CALHOUN ESTATES SUBDIVISION

The purpose of this application is to create 10 legal lots of record from one metes-and-bounds parcel.

DETAIL SITE PLAN 660.00' 66.00' 66.00 LOT 1 1 LOT 2 LOT 3 LOT 4 LOT 5 25' SEITBACK .00.099 .00.099 LOT 6 ľ LOT 7 LOT 8 LOT 9 LOT 10 660.00'

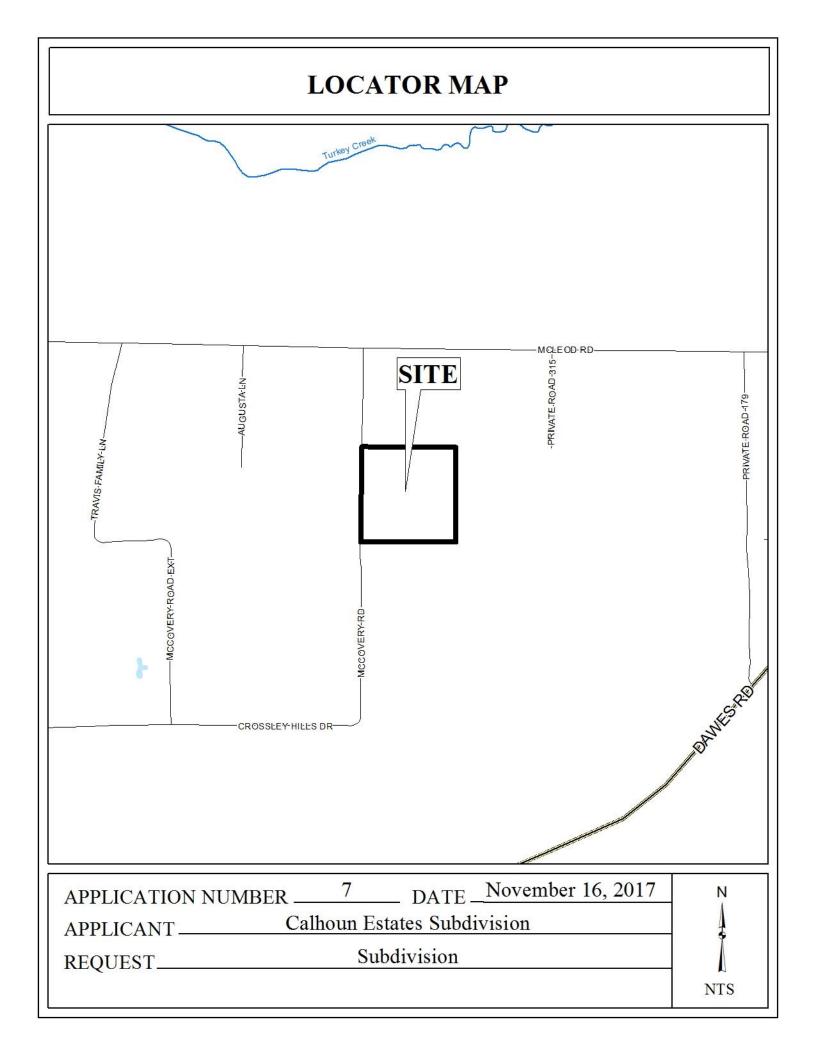
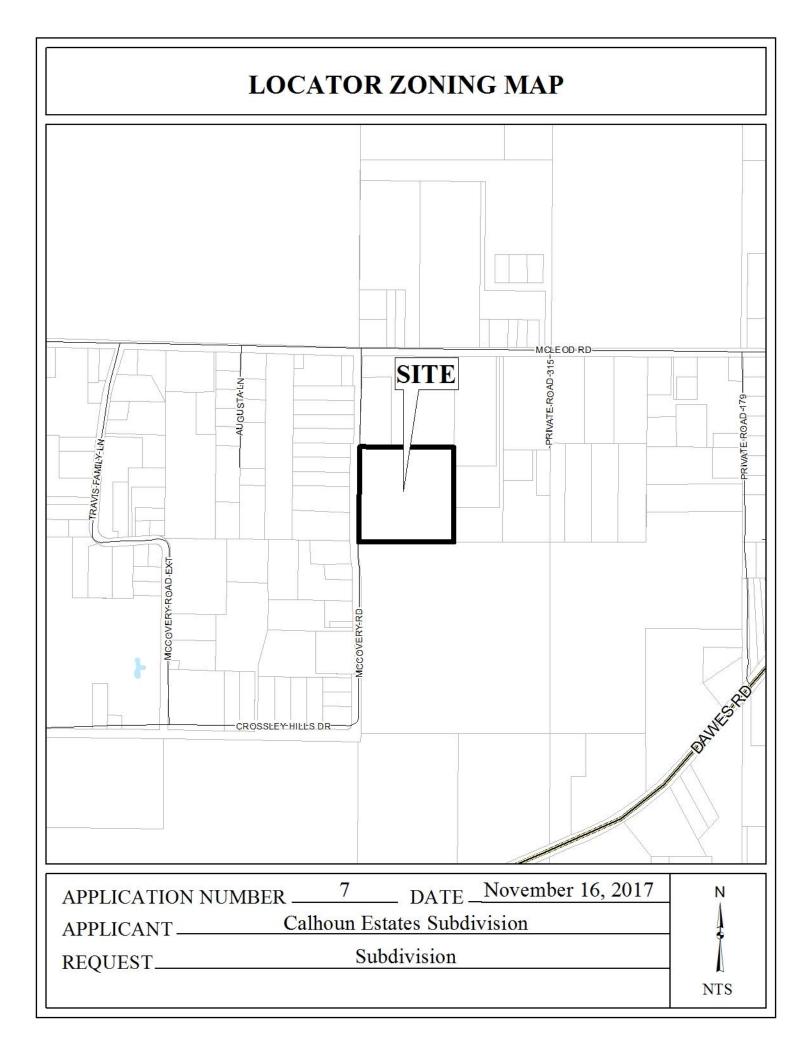
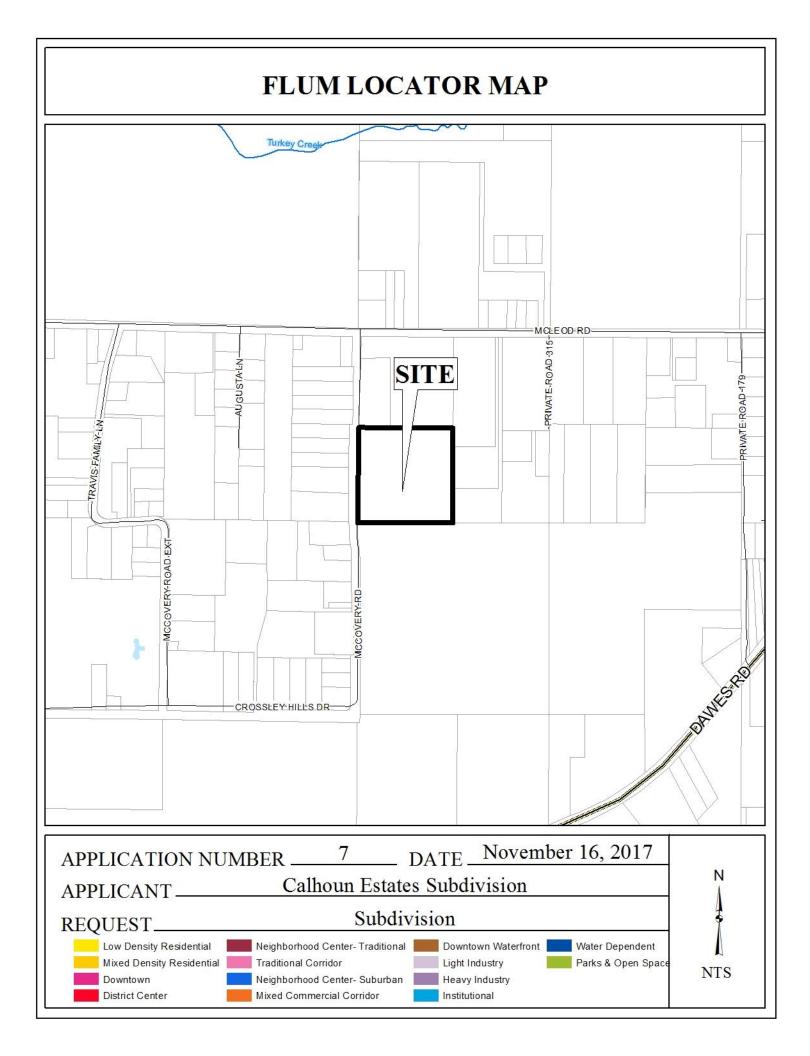
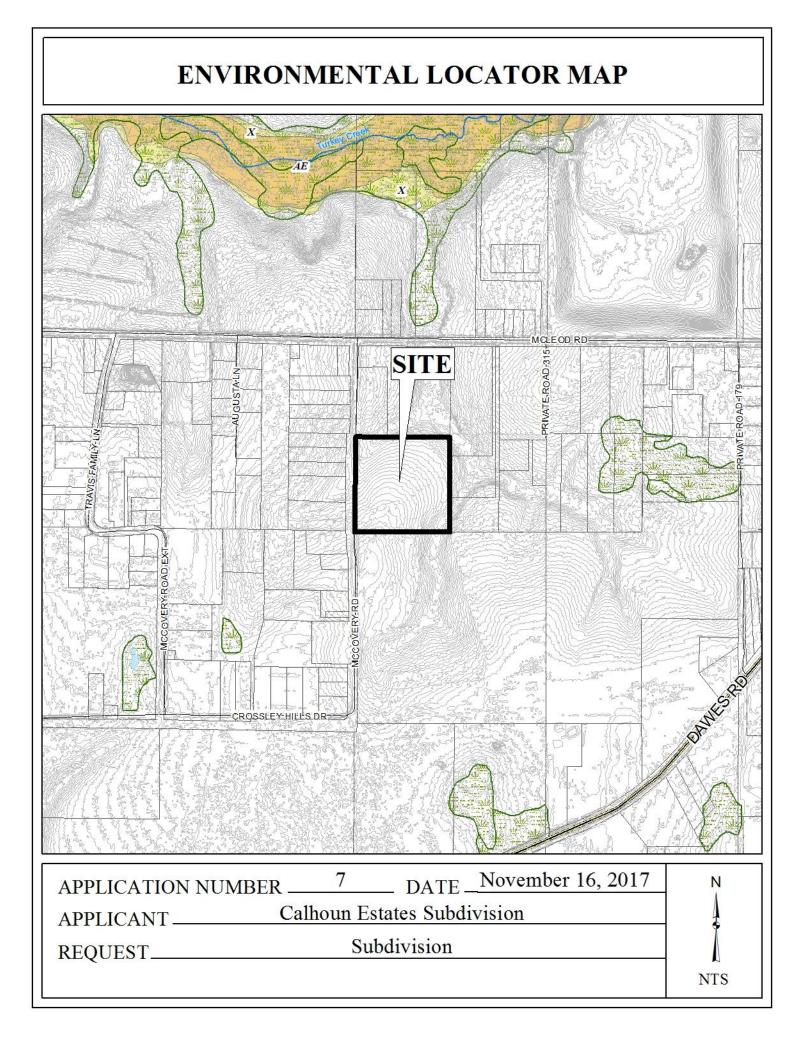
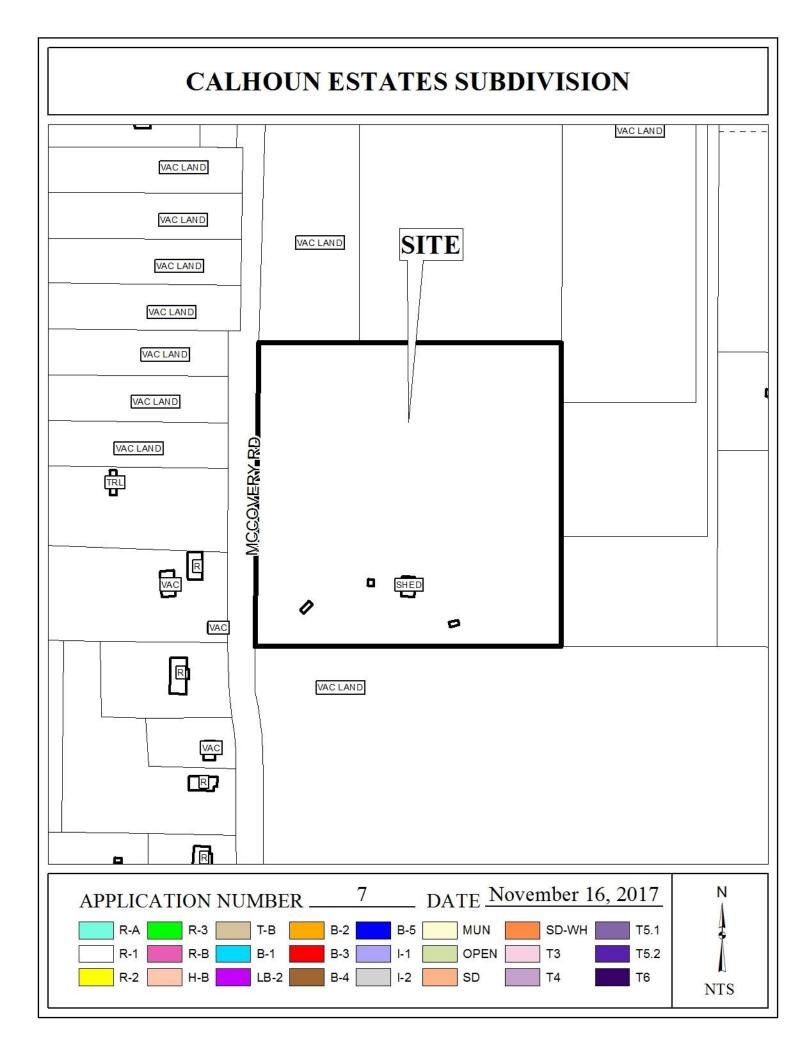
The proposed lots appear to meet the minimum size and frontage requirements (all proposed lots are 43,560 square feet) as regulated by Section V.D.2. of the Subdivision Regulations. However, the lots do not comply with Section V.D.3. of the Subdivision Regulations regarding the maximum width to depth ratio: a ratio of depth that is 3.5 times the lot width maximum, is recommended, however a depth that is 10 times the width is proposed. Thus, a waiver of Section V.D.3 will be required in order to approve the subdivision as proposed.

Due to the width and depth of the proposed lots, a note should be placed on the Final Plat stating that there shall be no future subdivision of any lot.

The proposed lots have road frontage onto McCovey Road, a minor street that is partially paved with existing gutters and very little curbing in some areas and unpaved along the rest. The site is located on the portion of McCovey road this is paved. The plat depicts McCovery Road as having an existing 40 foot right-of-way. A 60 foot right-of-way is required; therefore dedication to provide 30' from centerline will be required.

The 25-foot minimum building setbacks are shown and labeled on the preliminary plat; however the setback lines will need to be adjusted to reflect dedication. If approved, the corrected minimum building setback line should be illustrated on the Final Plat.

As a means of access management, a note should be placed on the Final Plat limiting each lot to one curb-cut to McCovery Road with the size, design, and location of all curb-cuts to be approved by Mobile County Engineering and conform to AASHTO standards.

The lot sizes are labeled in square feet and acres. If approved, the lot sizes in square feet and acres should be retained on the Final Plat, (revised for any required dedication) or the furnishing of a table providing the same information will be required.

This site is located in the County, thus any lots which are developed commercially and adjoin residentially developed property must provide a buffer, in compliance with Section V.A.8. of the Subdivision Regulations. A note regarding this requirement should also appear on the Final Plat, if approved.

- 1) no future subdivision of any lot due to the width/ depth ratio,
- 2) depiction of sufficient right-of-way to provide 30 feet from centerline from McCovery Road on the Final Plat;

- 3) retention of the labeling of the lots in square feet and acres, (revised for any dedication) or the furnishing of a table on the Final Plat providing the same information;

- 4) depiction of the 25' minimum building setback lines (to reflect dedication);
- 5) placement of a note on the Final Plat stating each lot is limited to one curb-cut to McCovery Road with the size, design, and location of all curb-cuts to be approved by Mobile County Engineering and conform to AASHTO standards;

- 6) placement of a note on the Final Plat stating that any lots which are developed commercially and adjoin residentially developed property must provide a buffer, in compliance with Section V.A.8. of the Subdivision Regulations;
